WATERVUE

643-651 HUNTER STREET NEWCASTLE NSW 2300

DEVELOPMENT APPLICATION SHEET LIST		
DRAWING NO.	TITLE	REVISION
DA000	PLAN - LOCATION & DRAWING SCHEDULE	F
DA002	SITE ANALYSIS	B
DA003	PREDICT LOCATION PLAN	C
DA005	SITE PLAN	B
DA006	SHADOW DIAGRAMS	B
DA007	SHADOW DIAGRAMS	B
DA008	SHADOW DIAGRAMS	A
DA009	SOLAR ACCESS DIAGRAM	B
DA010	VENTILATION DIAGRAMS	B
DA011	PLANNING - GFA	C
DA012	UNIT AREA FOR CARPARKING GEN.	B
DA101	GROUND FLOOR	E
DA102	PARKING LEVEL 1	D
DA103	PARKING LEVEL 2	C
DA104	PARKING LEVEL 3	C
DA105	PLAN - PODIUM	E
DA106	PLAN - TYPICAL LOWER	D
DA107	PLAN - TYPICAL UPPER	C
DA111	PLAN - PENTHOUSES	B
DA112	ROOF	B
DA200	STREETSCAPE ELEVATIONS	B
DA201	ELEVATIONS - NORTH AND EAST	F
DA202	ELEVATIONS - SOUTH AND WEST	C
DA301	SECTIONS	C
DA321	RAMP SECTION CARPARK	C
DA401	PERSPECTIVE	B
DA402	PERSPECTIVE	B
DA403	PERSPECTIVE	B
DA409	MATERIALS + FINISHES	B
DA801	PODIUM LEVEL PRIVACY SCREENS	A
DA802	SIGNAGE DESIGN INTENT	A

DRAWING No.	DA000
DRAWING TITLE	PLAN - LOCATION & DRAWING SCHEDULE
SCALE	1 : 1 @ A1
DATE	2023

DRAWING No. **DA301**
DRAWING TITLE **SECTIONS**
SCALE **1 : 200 @ A1**
DATE **2022**

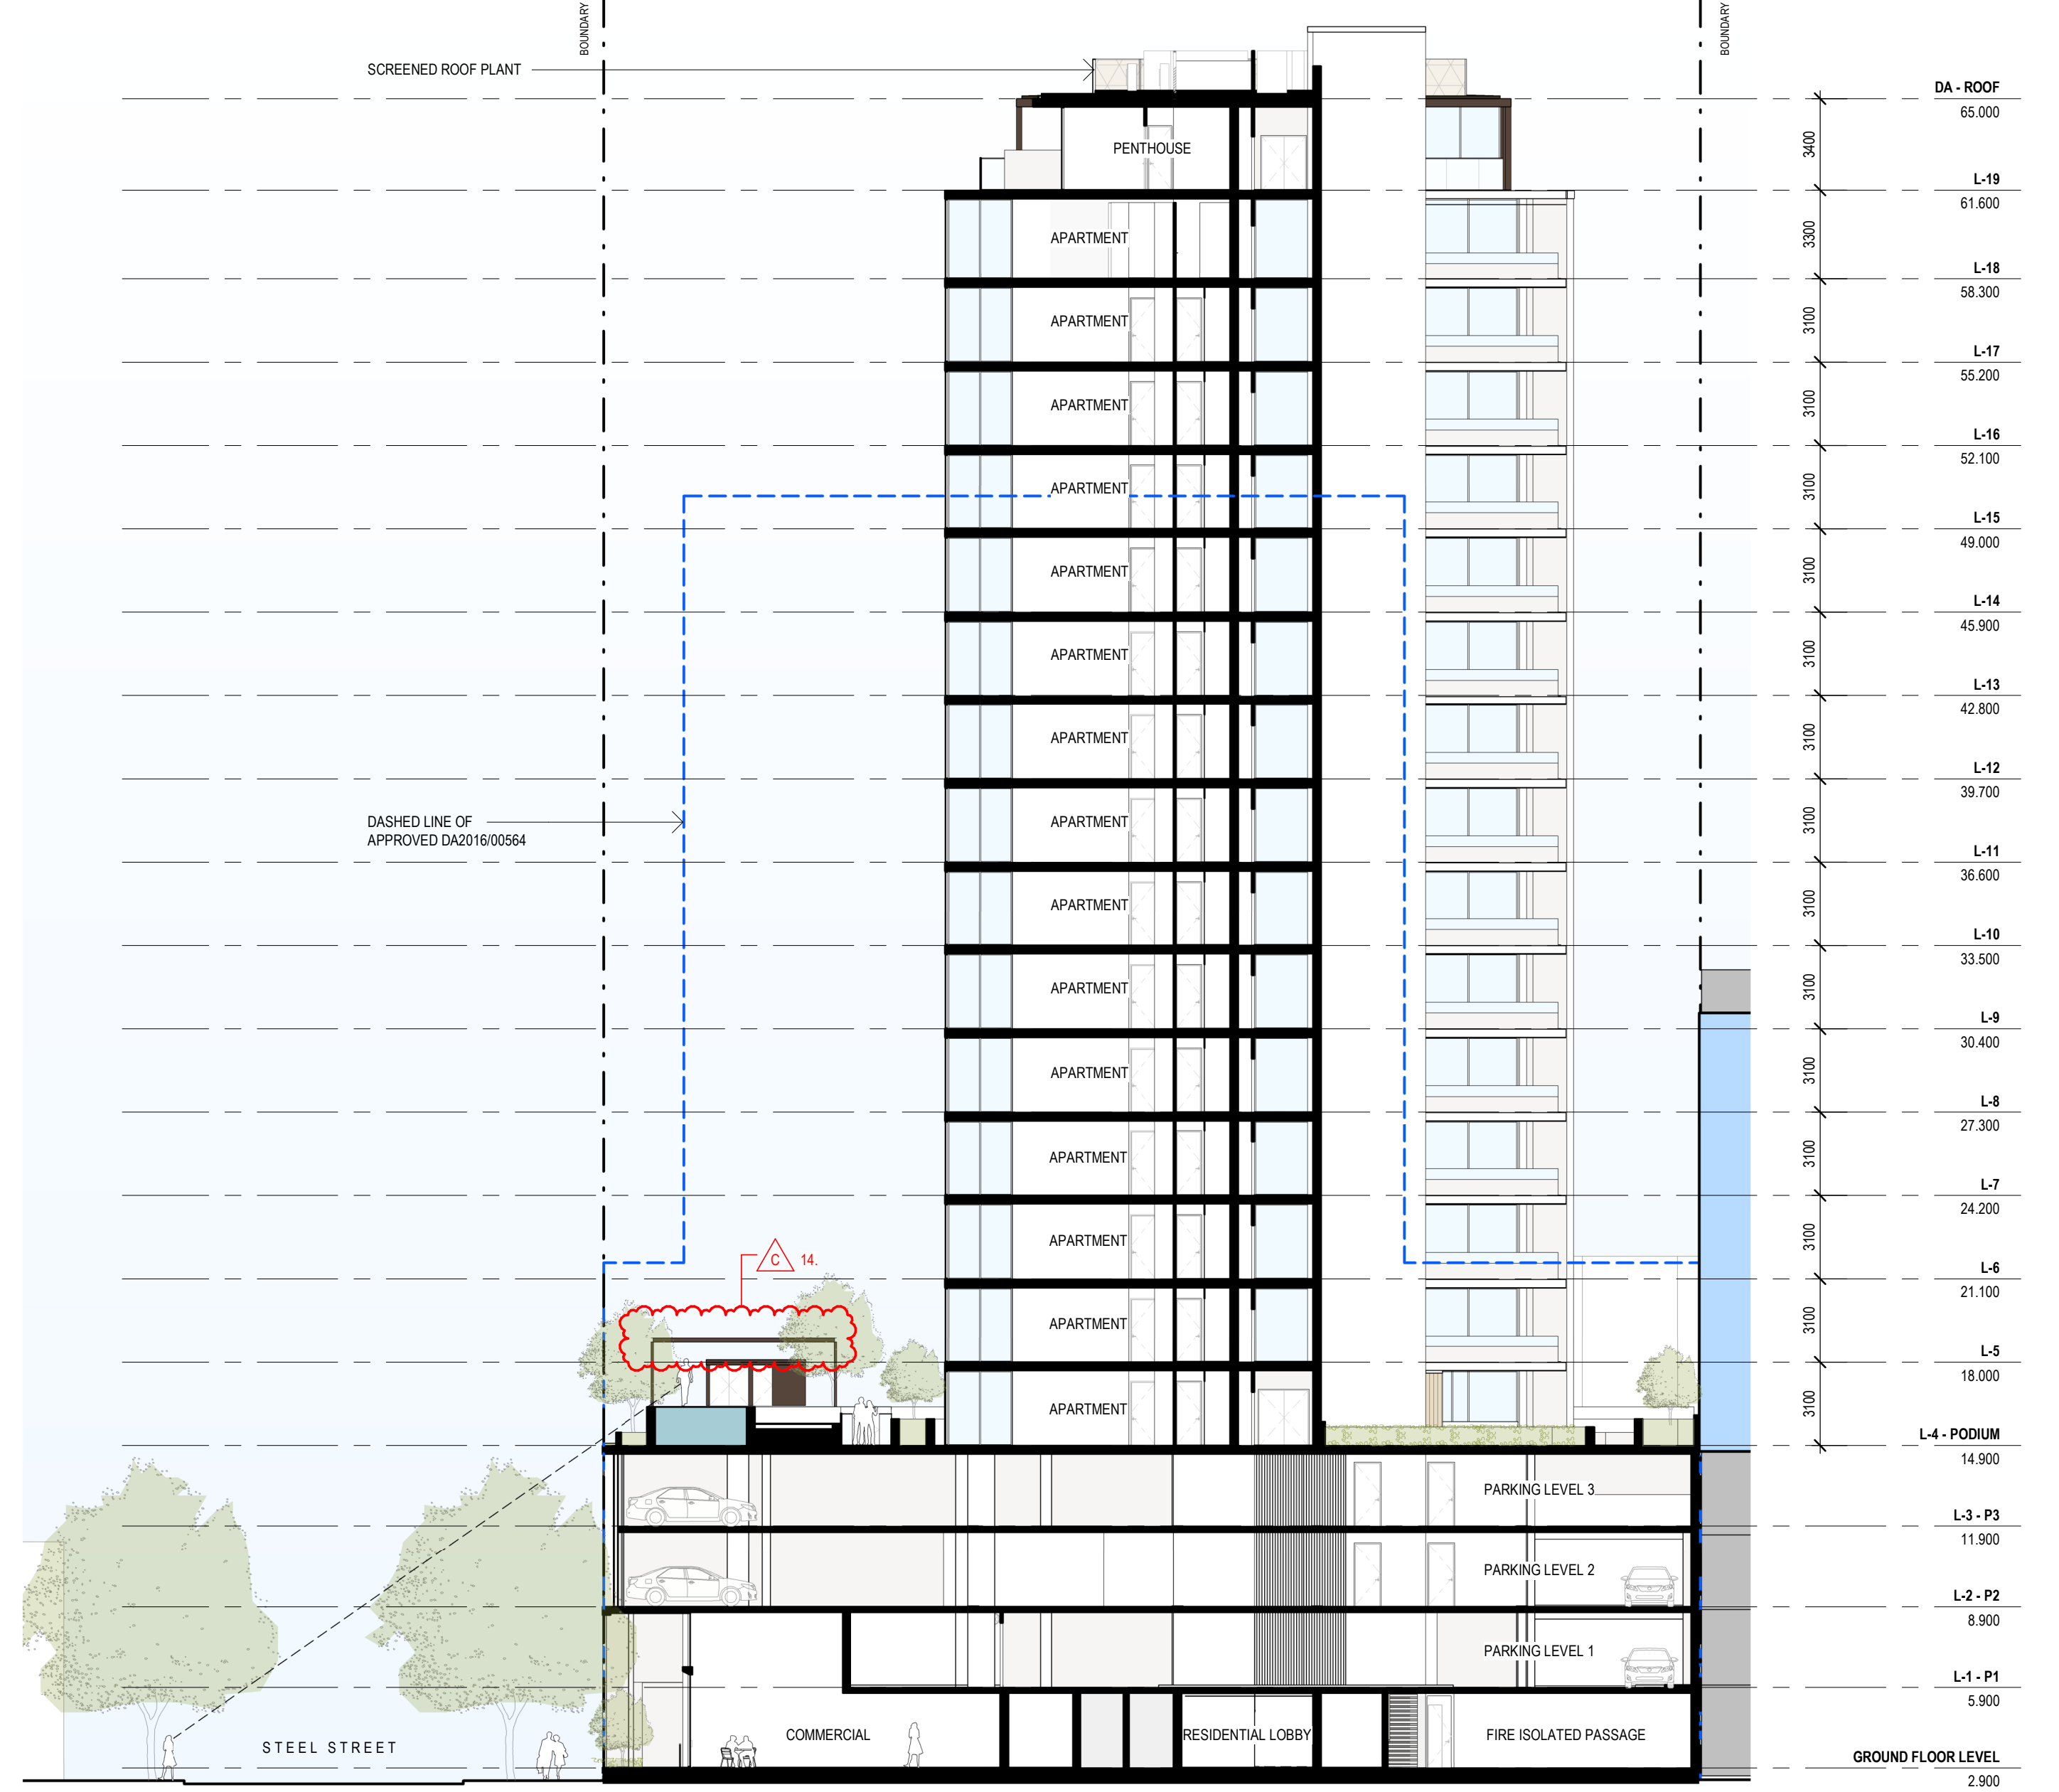
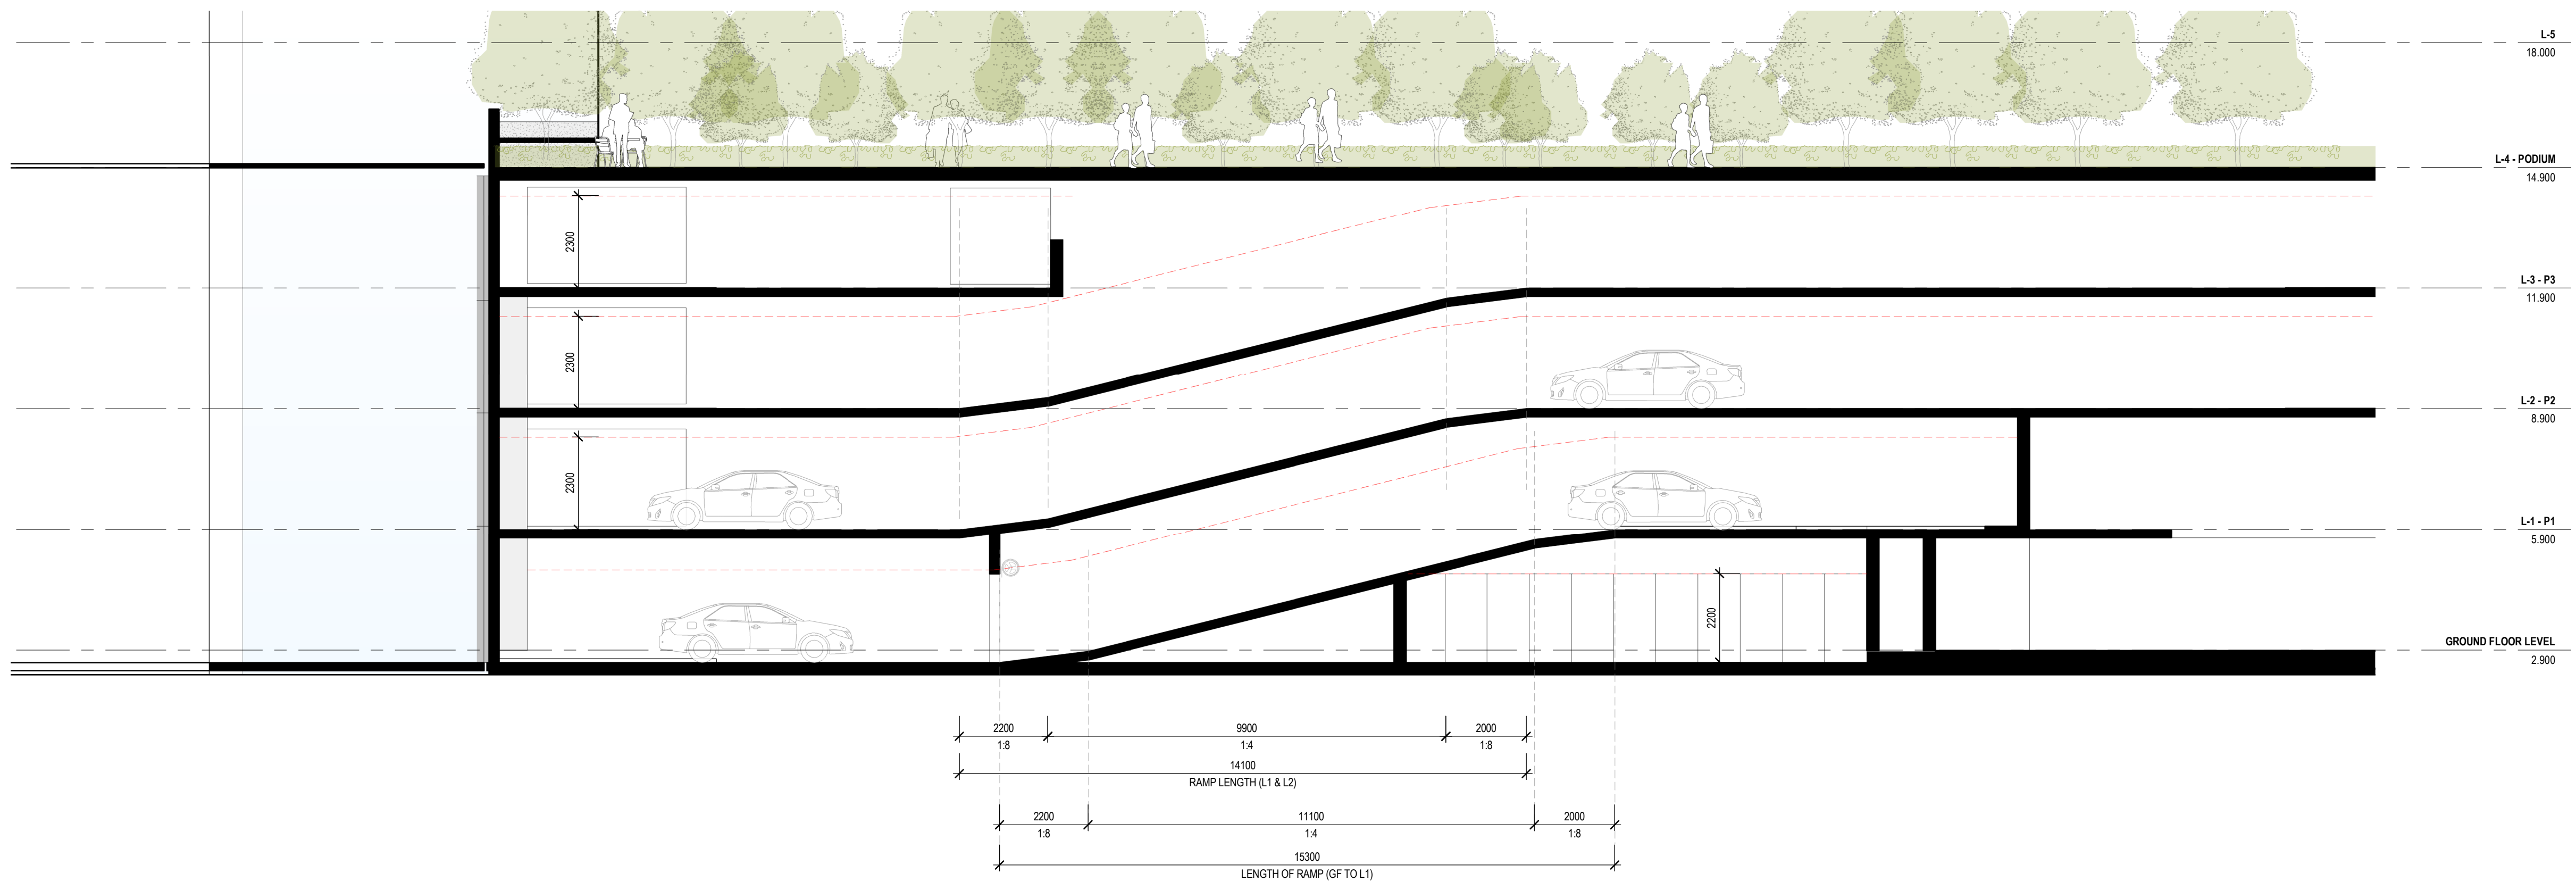
DA RFIS

1. GROUND FLOOR CARPARKING LEVEL LOWERED BY 300MM
2. DRIVEWAY GRADES UPDATED TO SUIT UPDATED PARKING LEVEL
3. DOOR TO FIRE EGRESS CORRIDOR RELOCATED
4. STEP ADDED TO FIRE EGRESS PATH TO SUIT UPDATED PARKING LEVEL
5. STEPS AND PLATFORM ADDED TO MSB ROOM TO SUIT UPDATED PARKING LEVEL
6. MAIL ROOM ADDED TO RESIDENTIAL LOBBY
7. MAILBOXES RELOCATED INTO THE RESIDENTIAL LOBBY
8. MOTORCYCLE SPACE DISTRIBUTION ACROSS L1, L2 AND L3 UPDATED (TOTAL REMAINS THE SAME)
9. SECURE ENTRY ADDED AT BASE OF RESIDENTIAL CARPARK RAMP GF TO L1 RAMP LENGTH UPDATED TO SUIT UPDATED GROUND FLOOR
10. PARKING LEVEL
11. GARAGE ADDED TO L1 AND L2
12. STORAGE CAGE ARRANGEMENT UPDATED
13. LANDSCAPE COURTYARD ACCESS DOOR ADDED TO PODIUM LEVEL
14. POOL PERGOLA SHOWN IN ELEVATION

DRAWING No. DA321
DRAWING TITLE RAMP SECTION CARPARK
SCALE 1:100 @ A1
DATE 2022

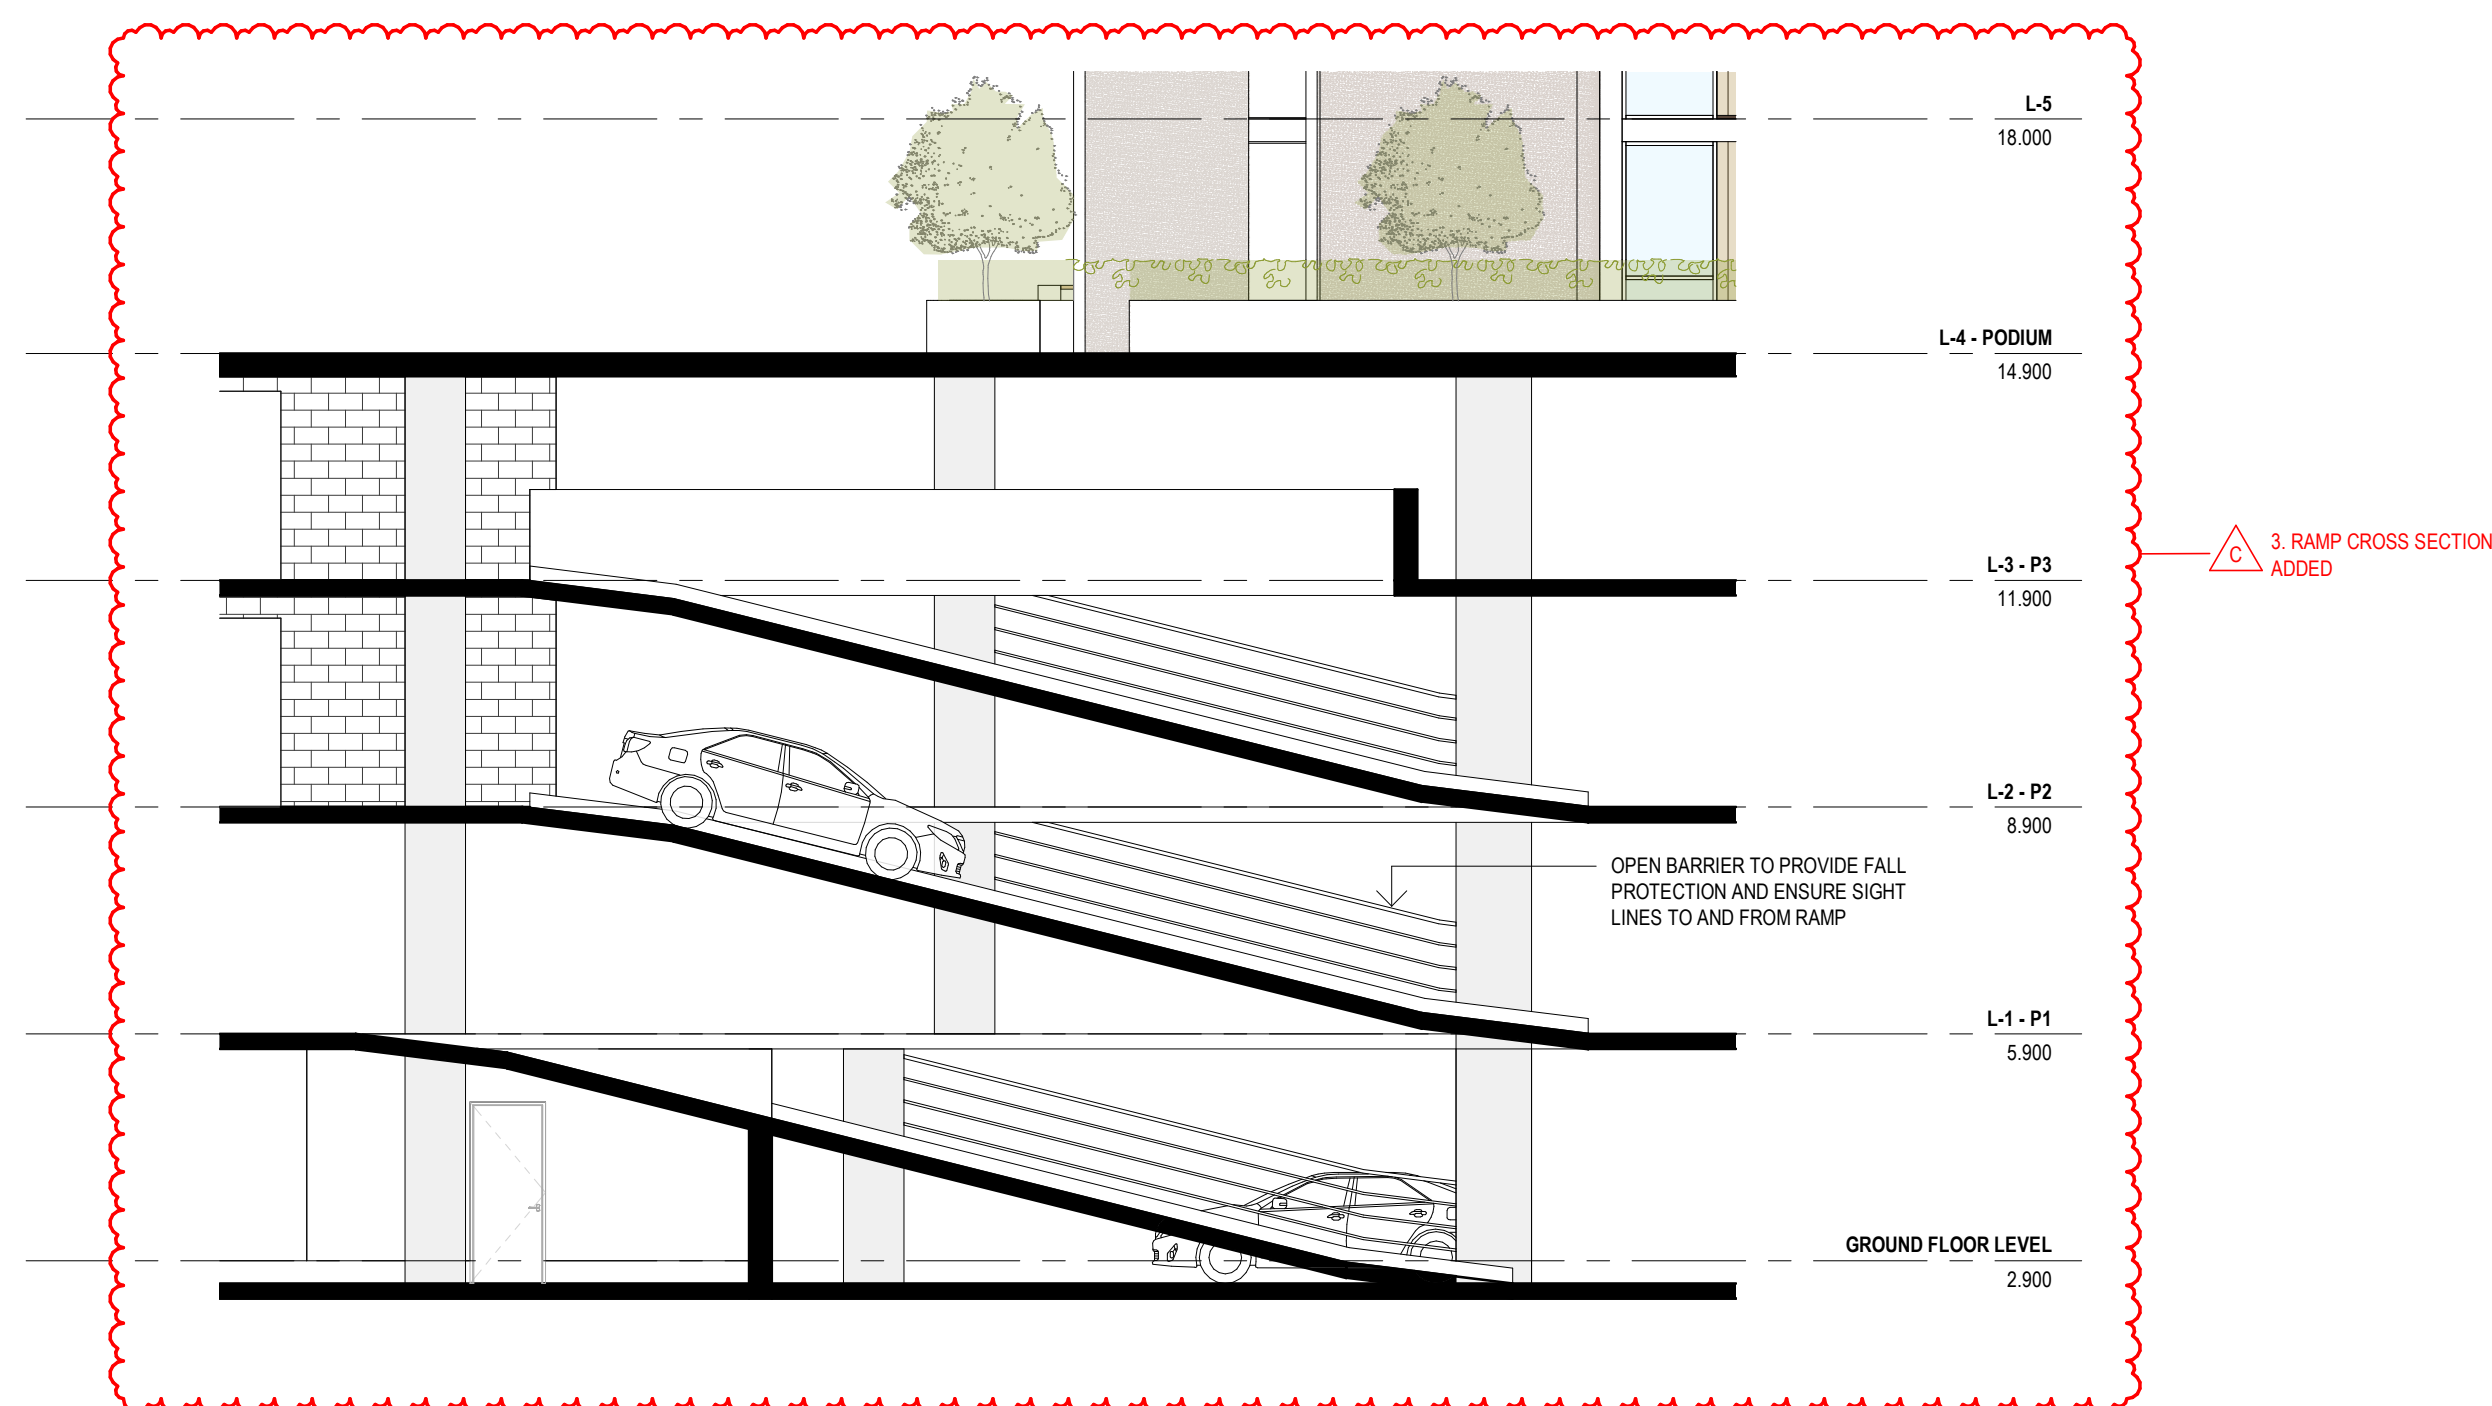
DA RFIS - 17.02.2023

1. NOTCHES IN AWNING ADDED
2. FUTURE STREET TREE CLEARANCE INDICATED
3. ADDITIONAL RAMP SECTION PROVIDED
4. RAMP EDGE CONDITION CLARIFIED
5. COMMERCIAL TENANCY STORAGE, WIC'S, COMMS ROOM, MAIL ROOM
6. RECONFIGURED TO CREATE FLOOD EVACUATION PATH
7. STAIRS REMOVED
